CITY OF ALBUQUERQUE

**Re: Cinnamon Morning - 2700 Rio Grande Blvd NW
Grading and Drainage Plan and Drainage Report
Engineer's Stamp dated: 1/16/2019 (G12D024)**

**CINNAMON MORNING CLUSTER DEVELOPMENT
GRADING & DRAINAGE PLAN**

GRADING AND DRAINAGE PLAN

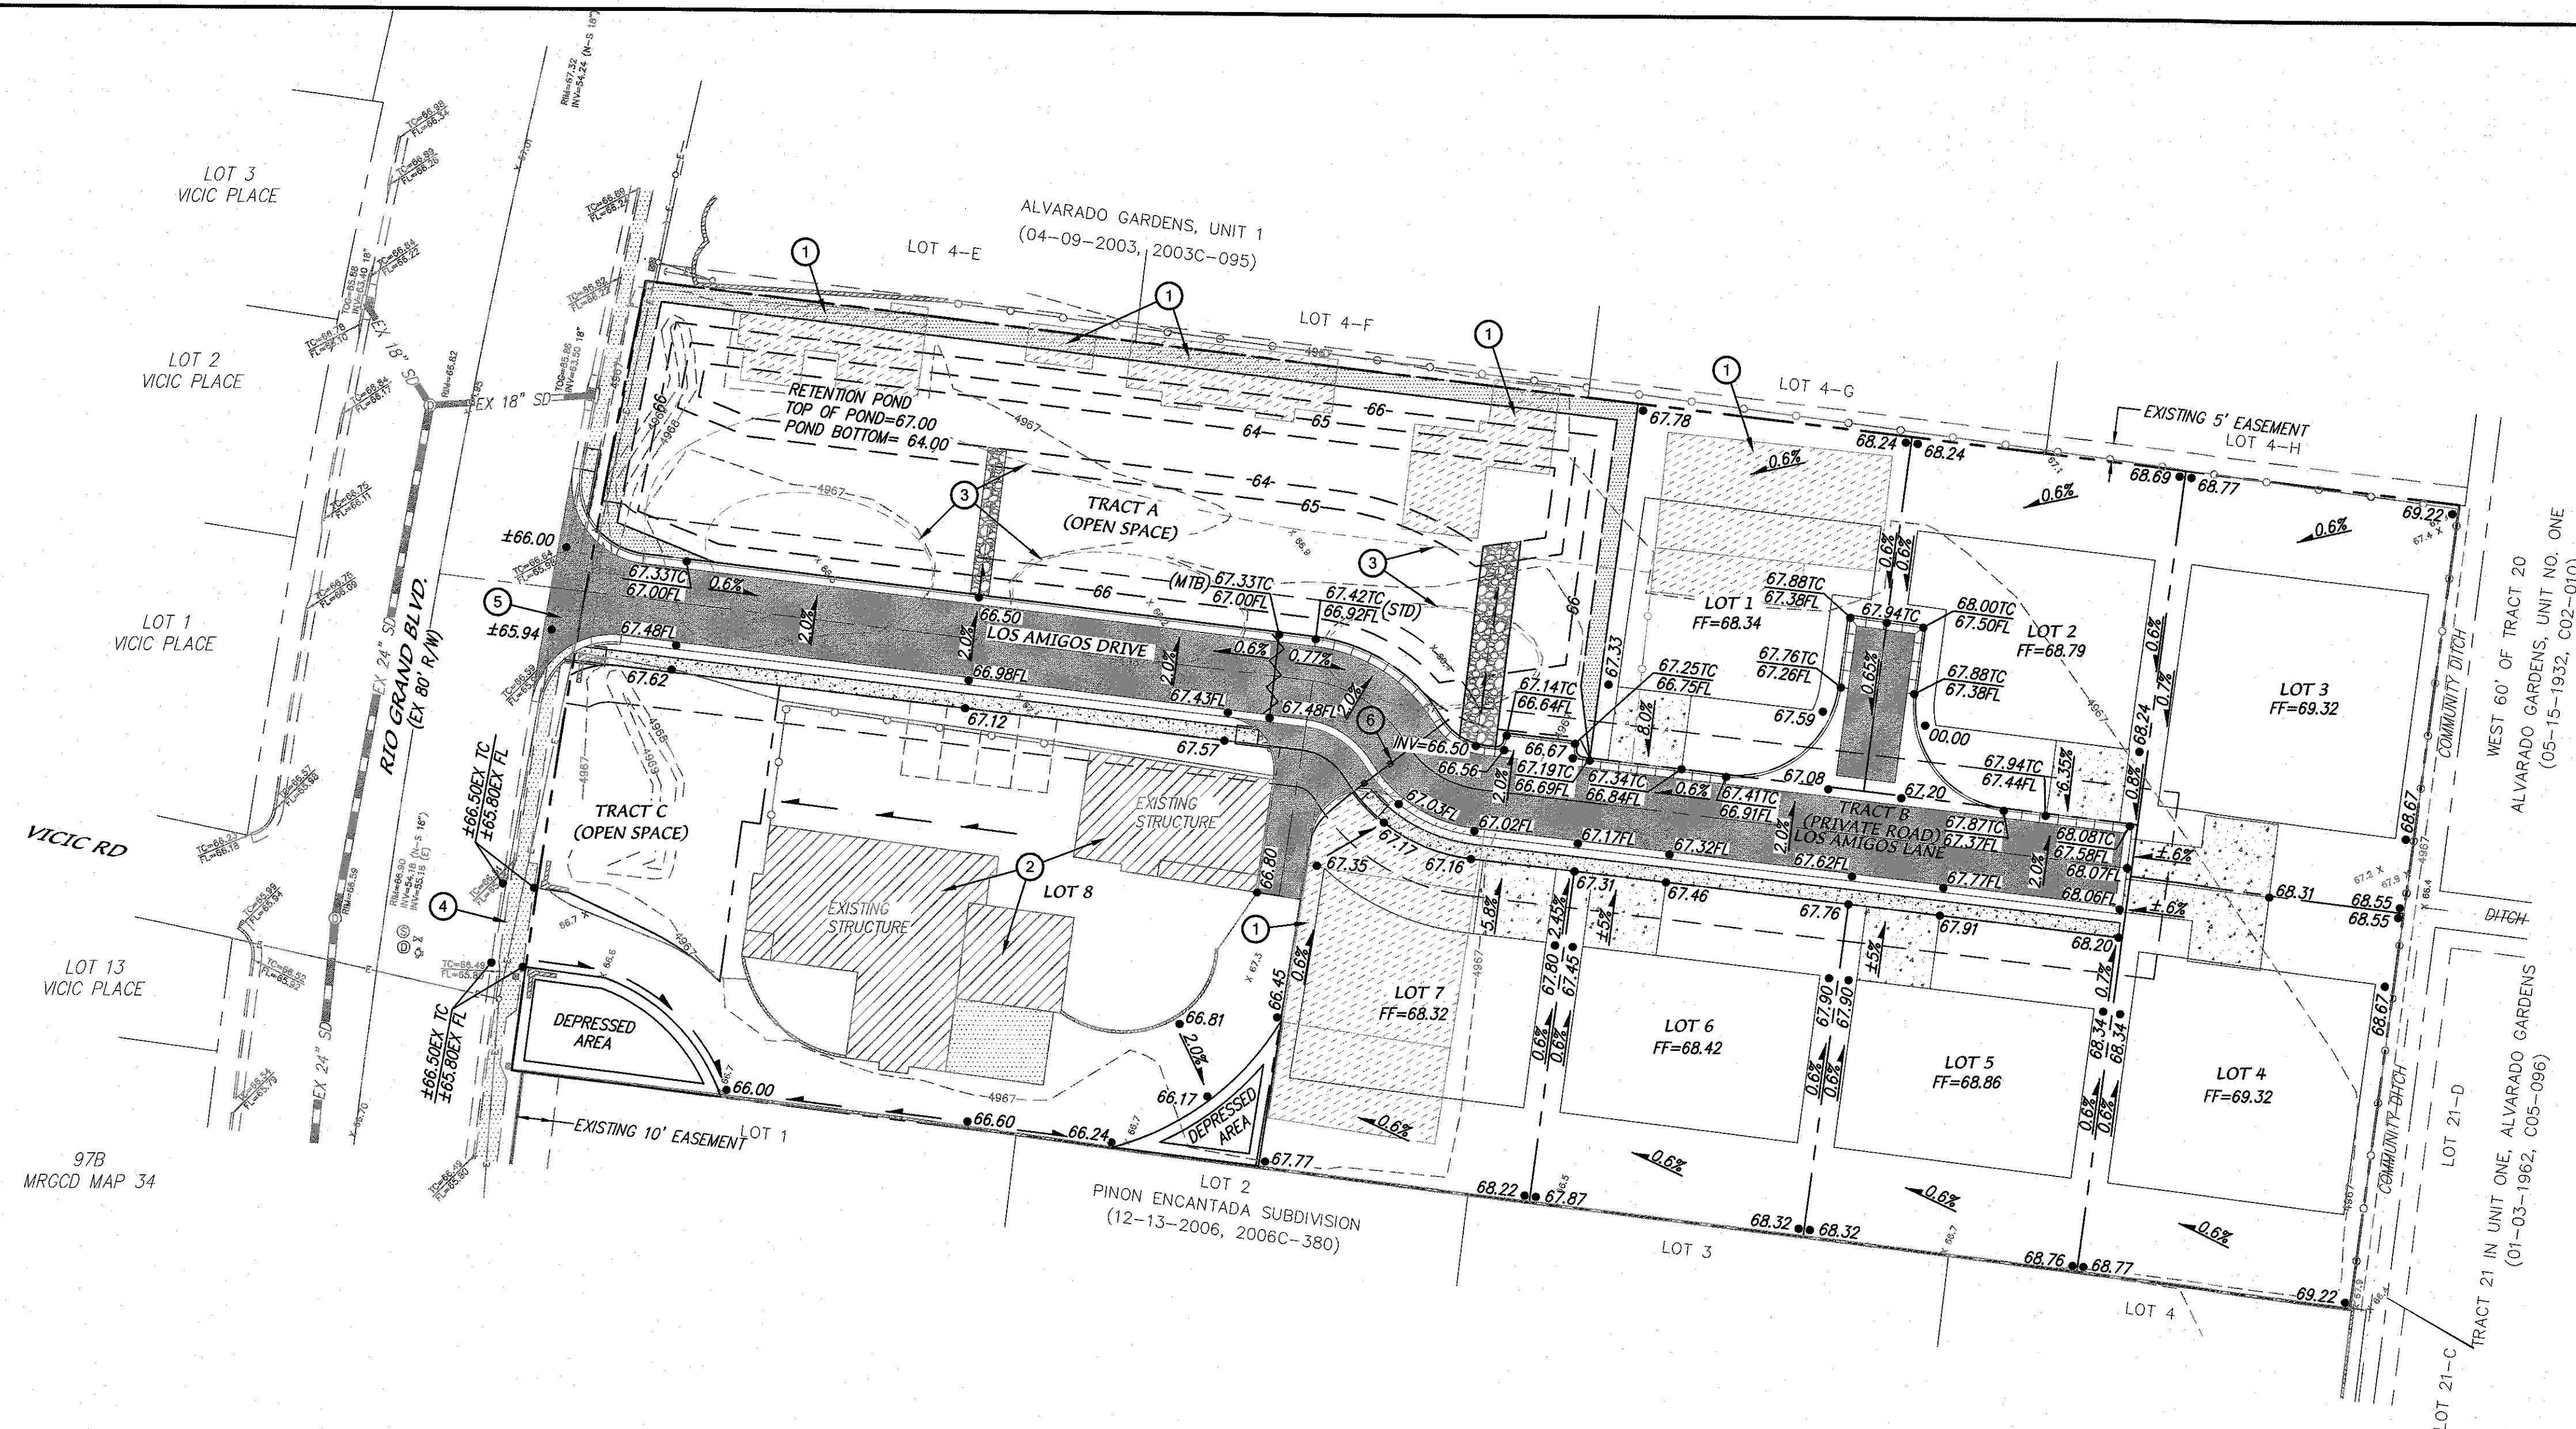
A Flat Grading Scheme, per DPM 22.5.G, is proposed which must include a block wall around the perimeter and onsite retention of the 100 year 10 day volume.

1. A block wall must be shown and labeled on both the G&D Plan and the Site Plan. Include a typical cross-section of the wall showing the proximity to the property line and the existing and proposed grades.
2. Existing spot elevations must be added on the adjacent property at each of the lot corners.
3. The hatch pattern at the edge of the pond must be identified and added to the legend.

4. The emergency spillway appears to be through Los Amigos Drive into Rio Grande Blvd. and should be sized for the peak 100 year inflow into the pond. Weir depth calculations are required on the G&D Plan to identify the emergency overflow elevation which must be lower than the Top of Pond.
